COMMONWEALTH OF VIRGINIA  
**COUNTY OF HENRICO**

RE:     POD2023-00111  
          The Hillside  
          **Site Plan**  
          Original Plan Review Comments II

The Planning Department has completed its review of the above-referenced plans, received **May 15, 2023** and has the following comments:

4. C-102

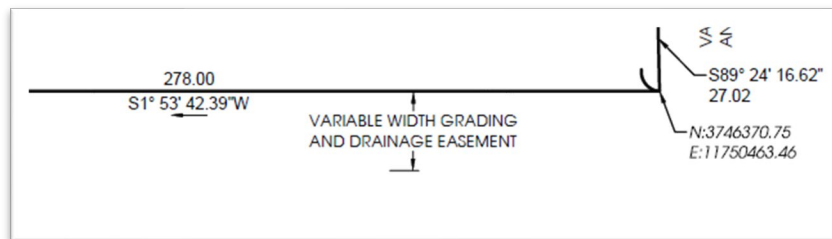
- A. Label the bold lines clearly. What are they indicating?

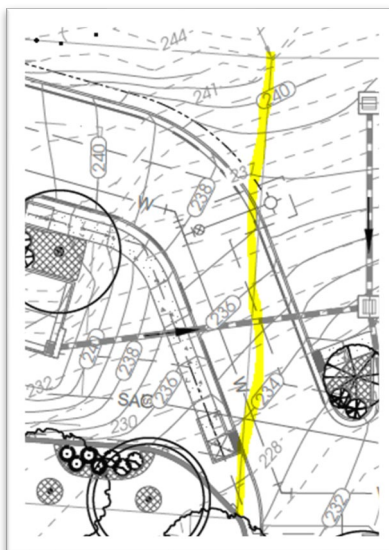
- C. Provide widths of proffered and transitional buffers.
  - D. The parking lot numbers need to be updated to 12 regular parking spaces in front of the Upperhill units and 20 regular spaces in front of the Downhill units.
  - E. A landscaped island must be provided in front of the Lower Hill units as they now exceed 19 (Section 24-5312D.2)
6. C-105
- A. Label existing sewer easement with deed book and page number.
7. C-108
- A. Either remove the "Variable Width Join Access and Maintenance Easement" or note that it is private and to be recorded under separate cover.
  - B. The "Variable Width Grading and Drainage Easement" on the Nottingham Green Apartment parcel needs to be shown in its entirety.
